Artesian 230kV Substation Expansion Project CPUC Minor Project Refinement Form

Report No.: MPR-9

The original work at Location 64 (E24) included overhead work only on the existing wood pole. This minor project refinement includes replacement of the existing wood pole with a weatherized engineered steel pole on a pier foundation.

Photo 1. Overview of access road and Location 64 (E24). View northeast.

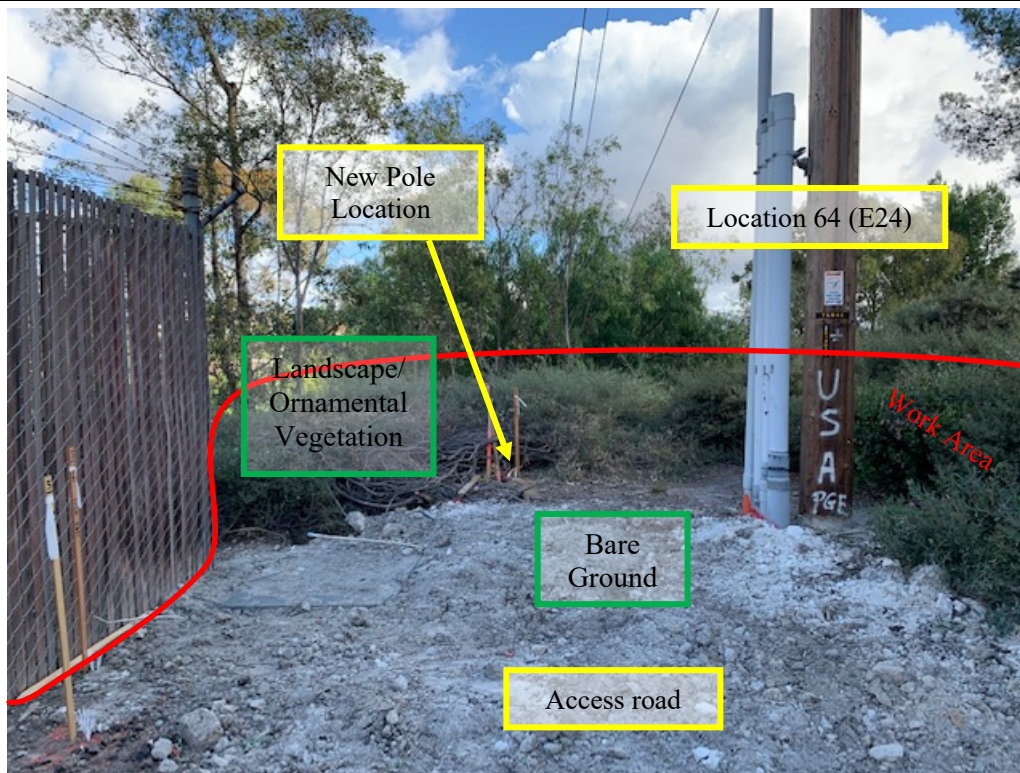
The photographs in Attachment A depict the proposed work area to be used for construction activities at Location 64 (E24). The original work activities at Location 64 (E24) included overhead work only, consisting of a 314 sq. ft. work area around the existing pole, plus access via an existing dirt road. The anticipated work area required is approximately 5,625 sq. ft. for the removal of the existing pole and installation of the new pole and associated pier foundation.

Figure 1
Location 64 (E24)

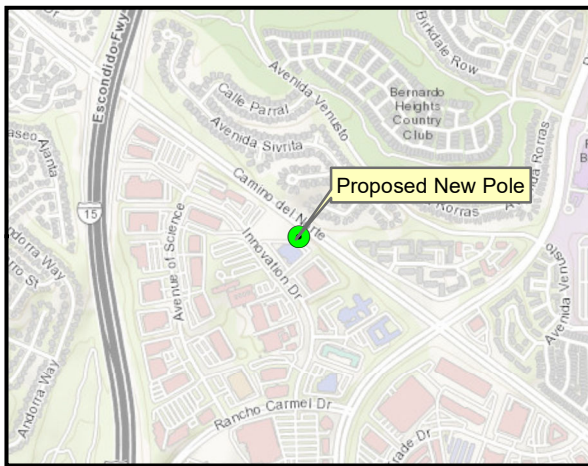
The original work at Location 64 (E24) only included overhead work on the existing wood pole. Guy wire and anchors for the existing pole are directly in conflict with the new underground trench package. Additionally, it was determined that a concrete foundation deadend pole would be required for reliability reasons as the overhead span crosses a major thoroughfare. Therefore, the existing pole at Location 64 (E24) needs to be replaced with a weatherized engineered steel pole on a pier foundation.

Refer to Figure 1 in Attachment B. Figure 1 depicts the Location 64 (E24) work area. The work area will be positioned mostly towards the existing project-approved dirt access road, south of the new pole location, with an approximately 30-foot radius behind the existing and new pole locations for equipment access. The access road portion of the work area will overlap largely with the existing project work areas for underground trenching and wire stringing.

The anticipated work area required is approximately 5,625 sq. ft. at the new pole location. The new concrete pier foundation will be approximately 7 feet wide and 19 feet deep.
